## **GAROB DEVELOPMENTS LIMITED**

### **PROPOSED CHANGE OF USE, FROMER CO-OP, WELL STREET, CEFN MAWR, WREXHAM**

#### **TN03 – RESPONSE TO LHA COMMENTS**

**12<sup>TH</sup> JULY 2023**

## **APPENDIX 1 – PROPOSED SITE LAYOUT**

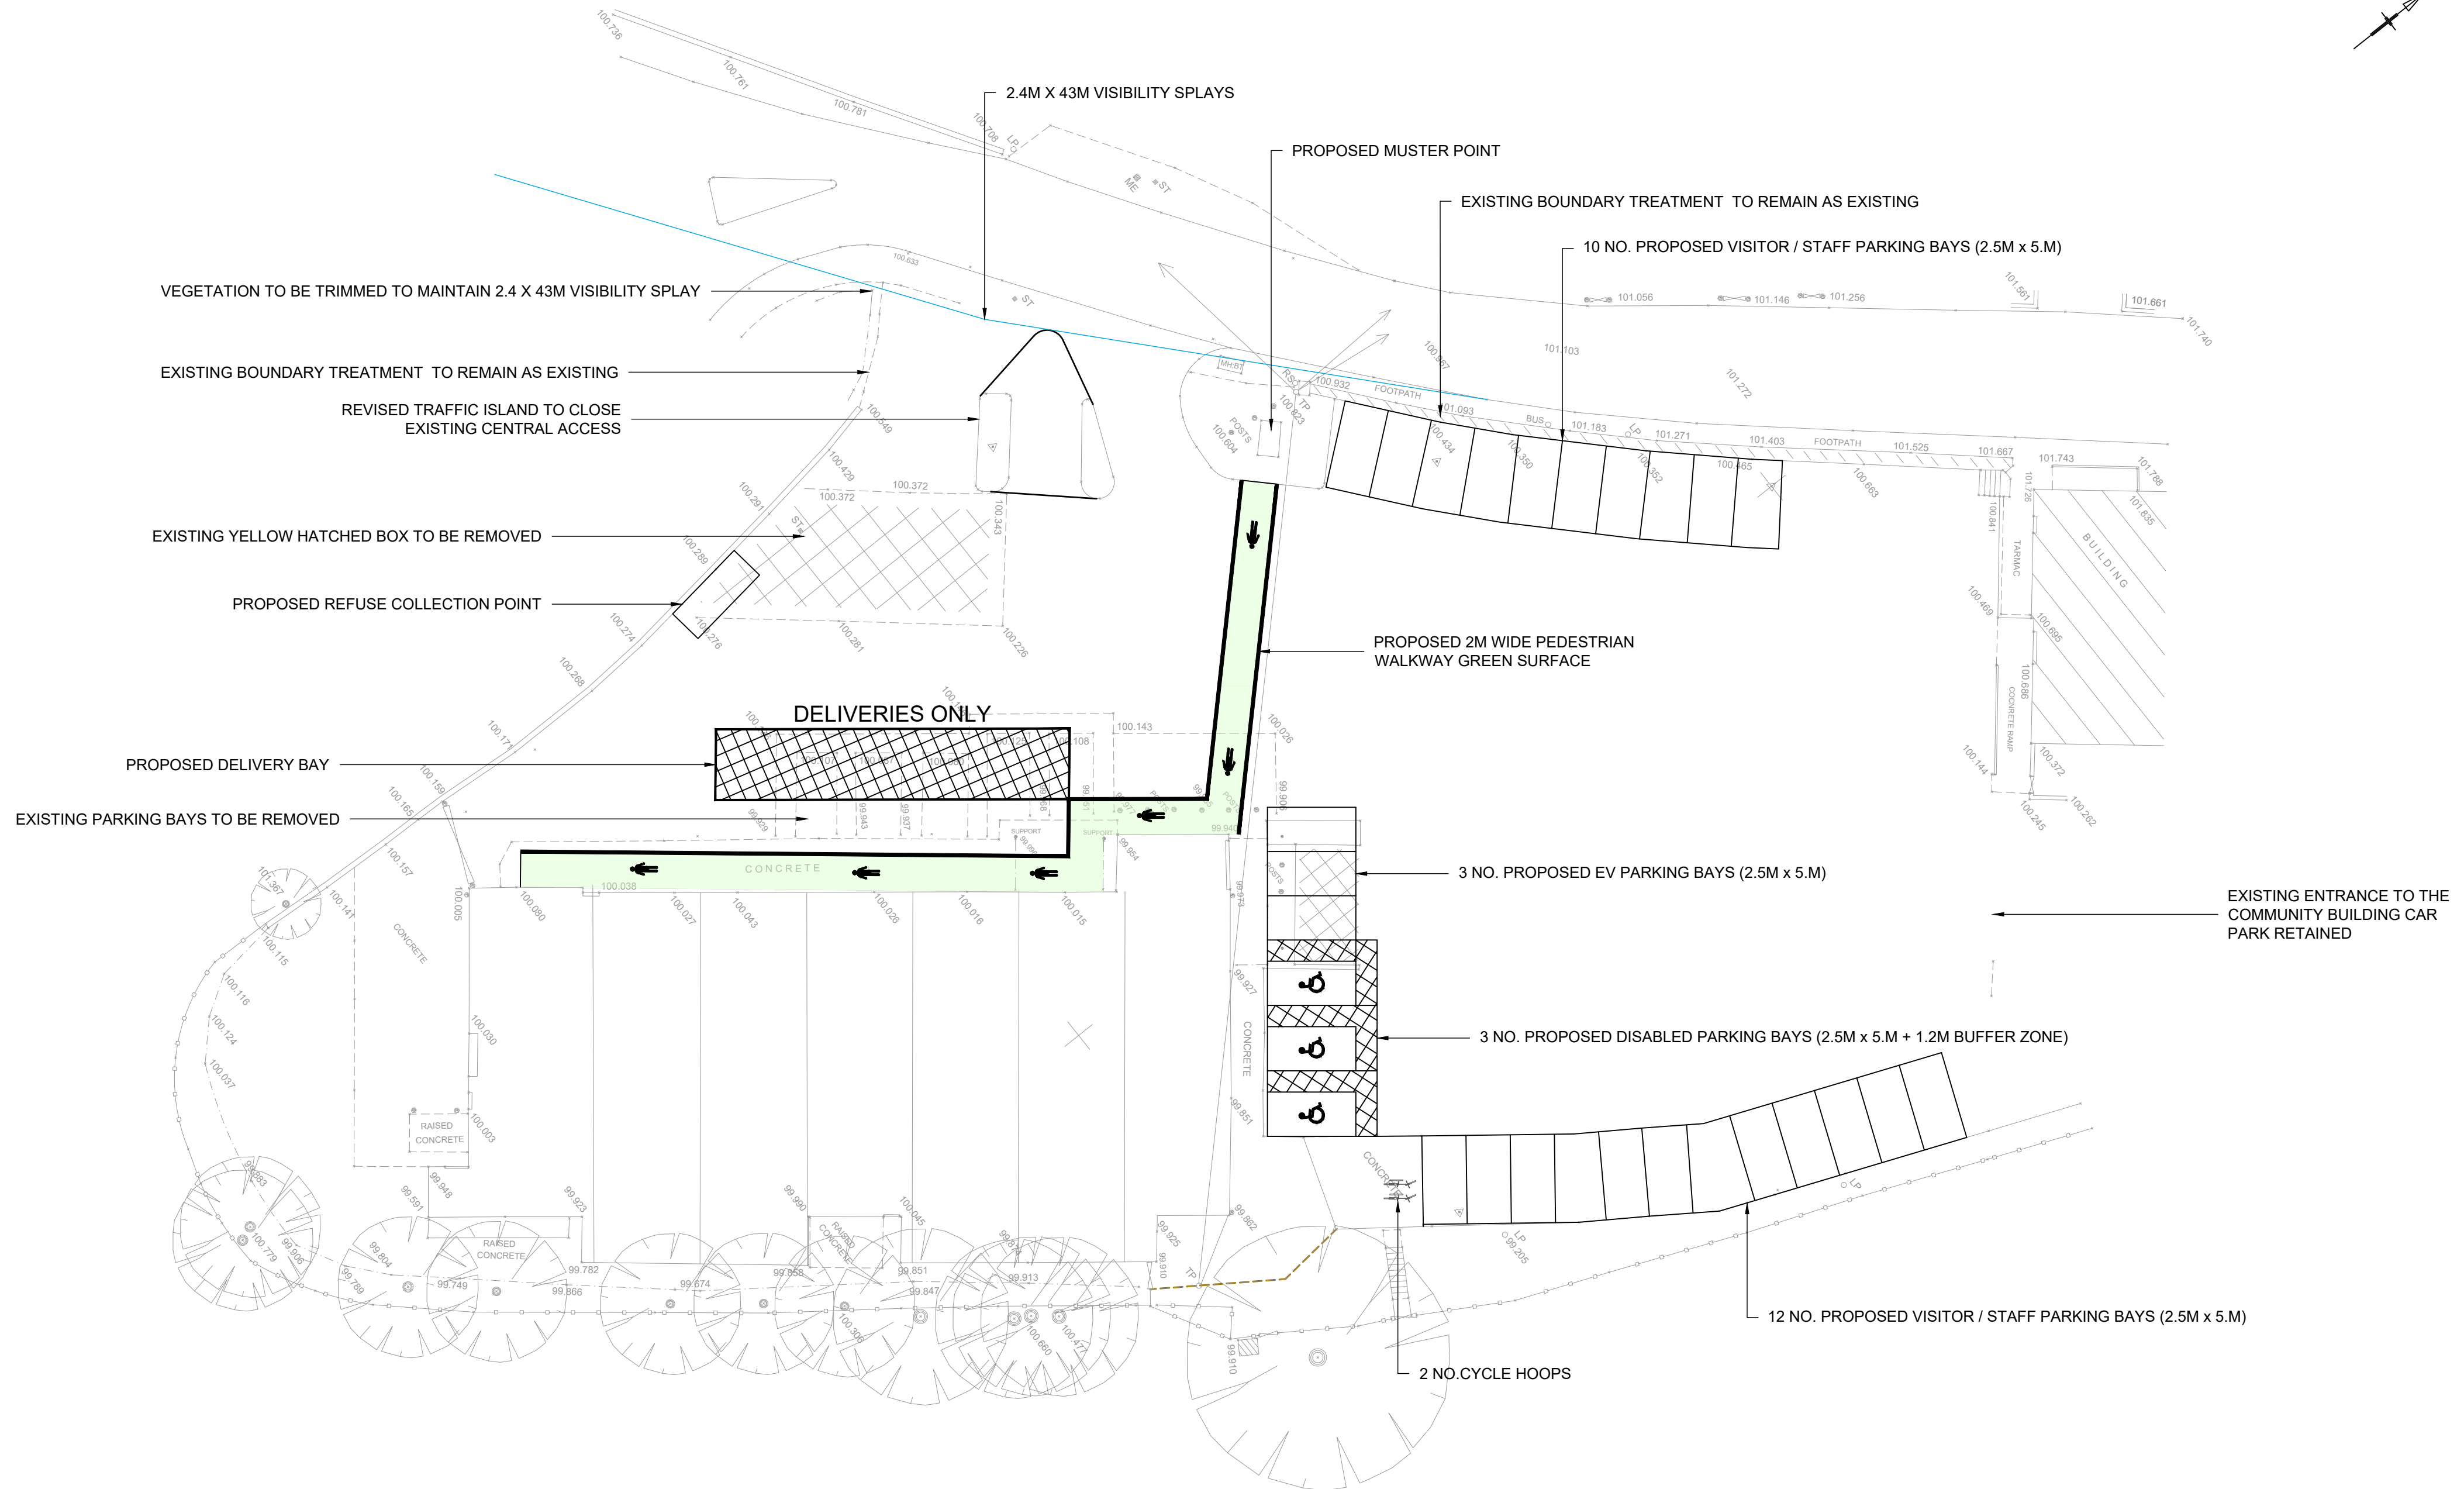
- 3.1 The following comments by the LHA refer to the additional information provided by Connect as part of the previous correspondence: *"As discussed, we are comfortable with the additional information provided, subject to the following qualifications:"*
- 1. The scrub/weeds to the right of the entrance can be removed and maintained to below 1m high, and a plan will be provided showing visibility splays each way. I know the junction quite well and am comfortable that with this improvement, visibility will be well within requirements for a 20mph speed limit in place on Well St.*

*2. Swept path analysis has been provided for both articulated and rigid HGV's both of which are permitted under the current site classification. We note our agreement that adjustment to the central islands may be necessary, which we can agree in due course via a pre-commencement condition as noted below. These alterations may provide central refuge to pedestrian traffic given the size of the opening.*

*1. On-site vehicular parking for staff and customers, and any third party spaces for commercial premises along the north east boundary (if applicable). Proposals and layout needs to comply with LPG16.*

*3. Safe pedestrian movement both across the entrance and across the site, compliant with DDA and Active Travel Requirements Wales.*

*8. Surface water drainage and demonstration that no surface water will discharge onto the public highway.*

- 3.2 The proposed site plan provided at Appendix 1 shows visibility splays of 2.4m x 43m on the site access approach, which complies with the requirements set out in Manual for Streets 2 for roads subject to a 20mph speed limit. Vegetation will be managed to maintain these splays.

- 3.3 The proposed site plan shows that the existing central access will be closed to form one refuge island, which will provide a central respite area, and allow for shorter crossing distances across the access.

- 4.2 The parking spaces shown on the proposed site layout at Appendix 1 have been provided with reference to the parking standards in LPG16.

- 4.7 The proposed site layout shows a marked pedestrian route along the building's western frontage, which extends across the car park to the footway on the north side of the access.

- 4.12 The site plan shows decreasing levels at the site access away from the highway, such that surface water in the site will discharge to the rear of the site and not onto the highway.

- 4.13 The proposed car parking spaces and landscaping alterations are shown on the site plan at Appendix 1.

title  
PROPOSED SITE LAYOUT  
SWEEP PATH ANALYSIS  
FTA DESIGN ARTICULATED VEHICLE

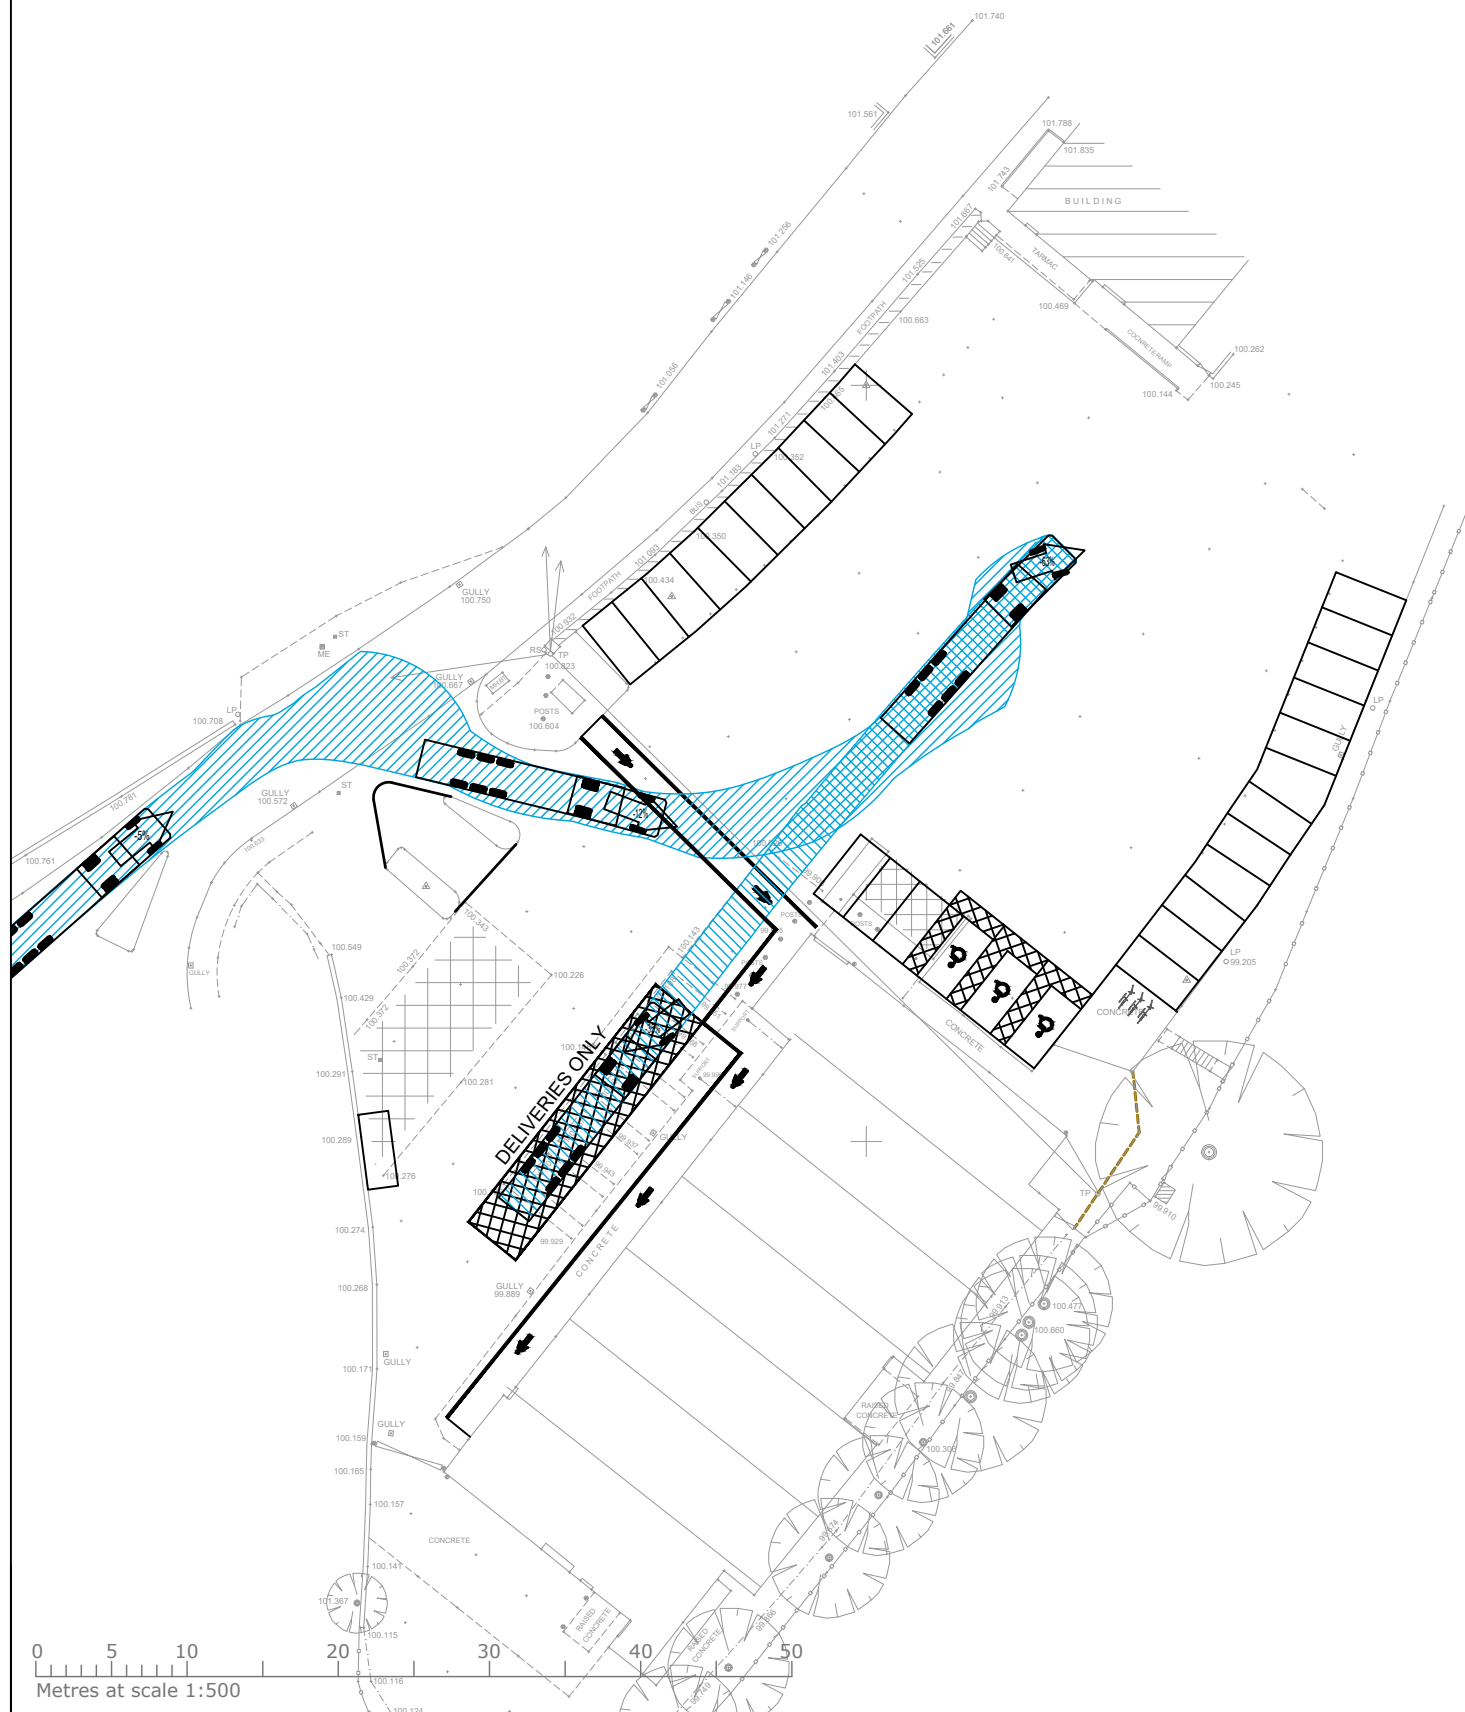
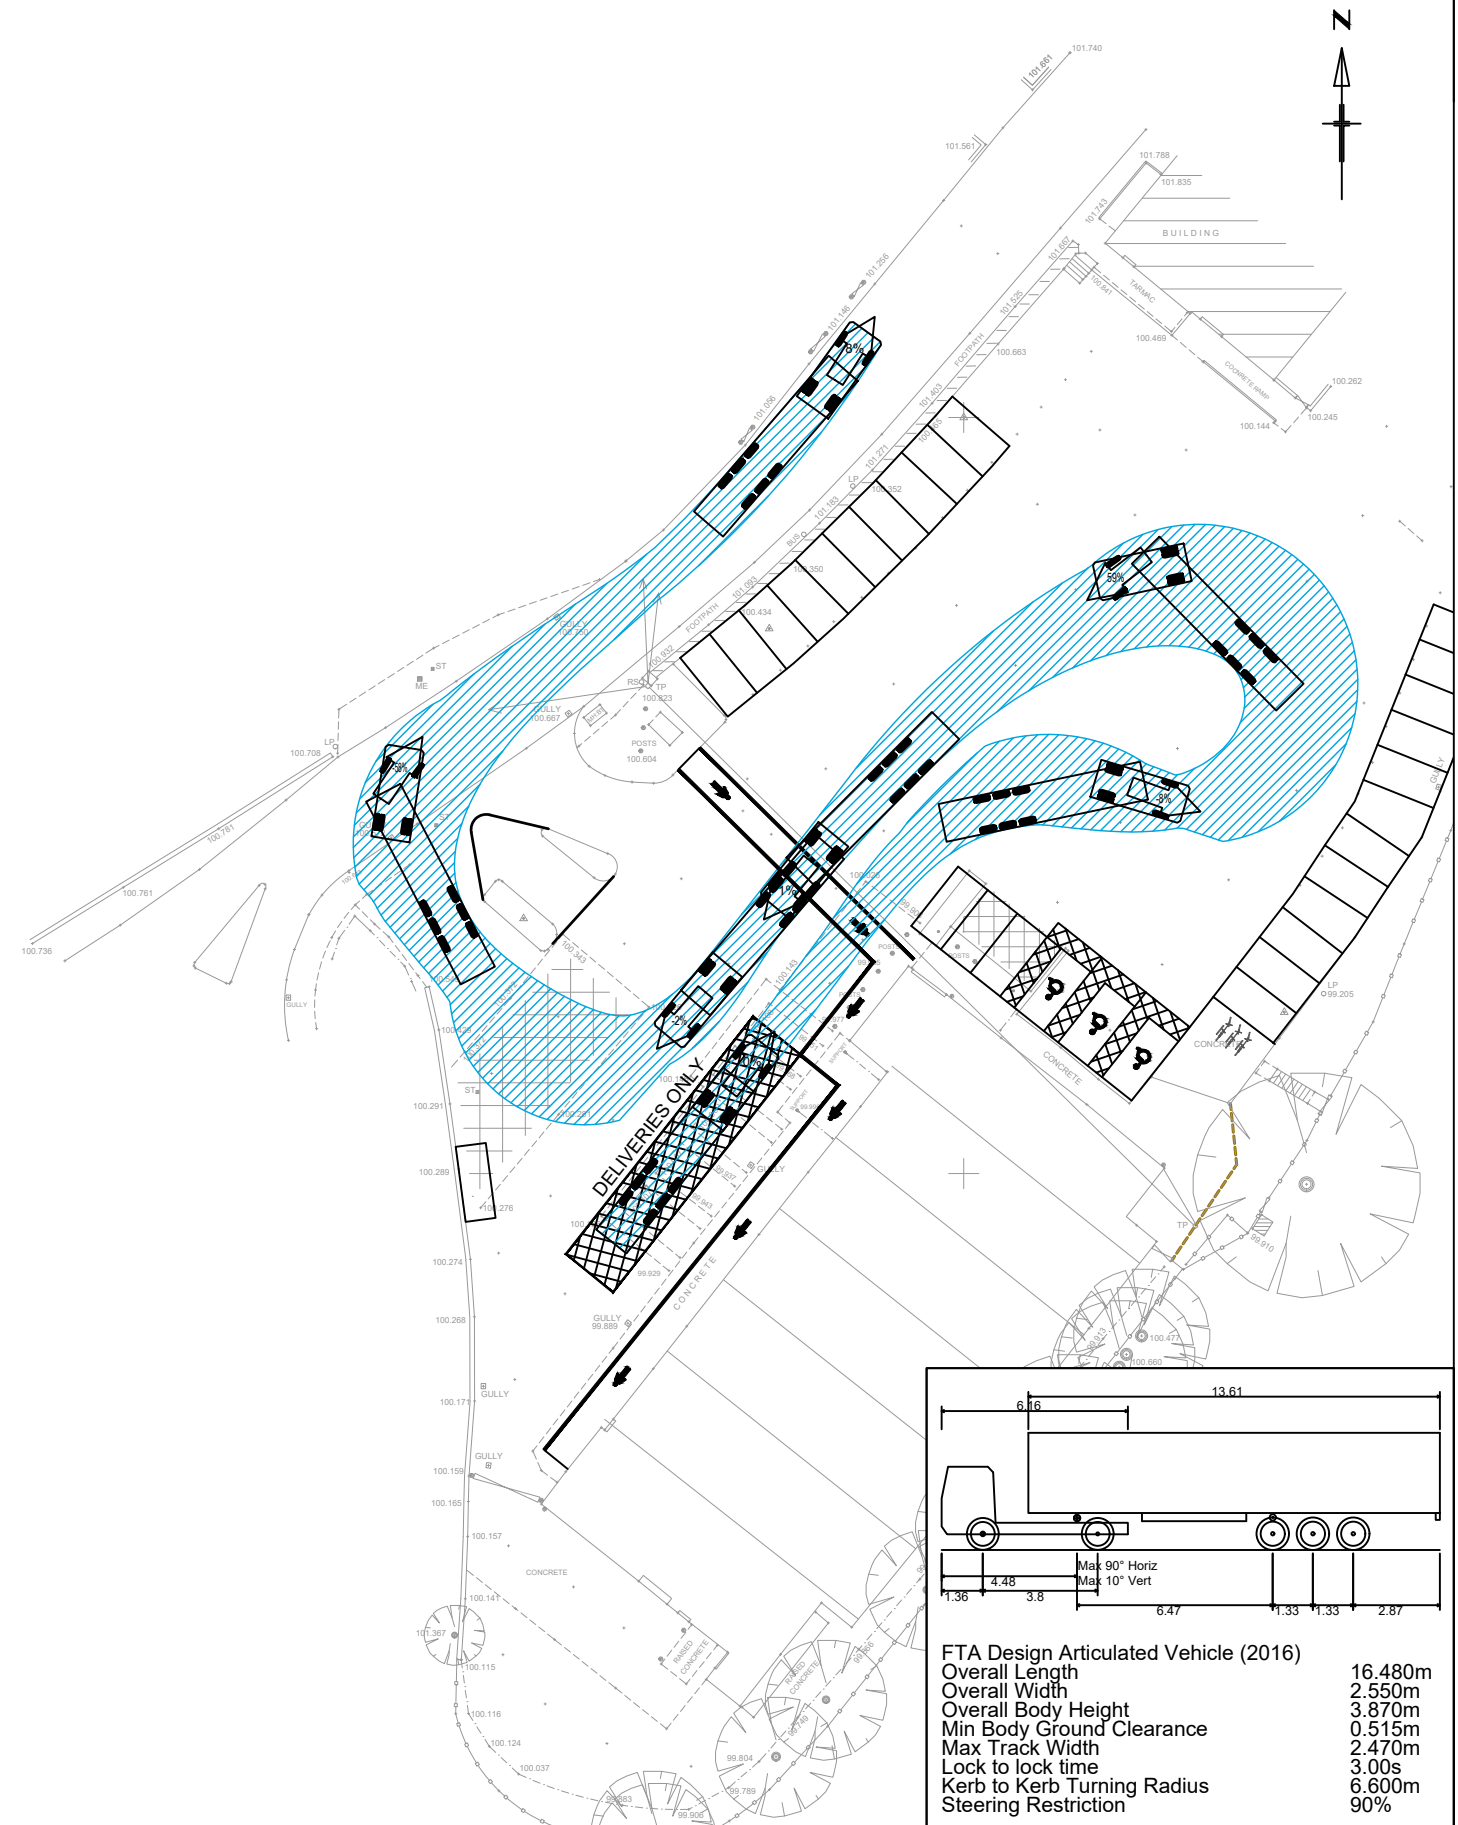
*2. Deliveries and servicing of the proposed premises*

- 4.6 A marked dedicated delivery and servicing area will be situated fronting the western side of the building. The swept path analysis at Appendix 2 demonstrates that 16.5m articulated and 10m rigid vehicles are able to manoeuvre within the site.
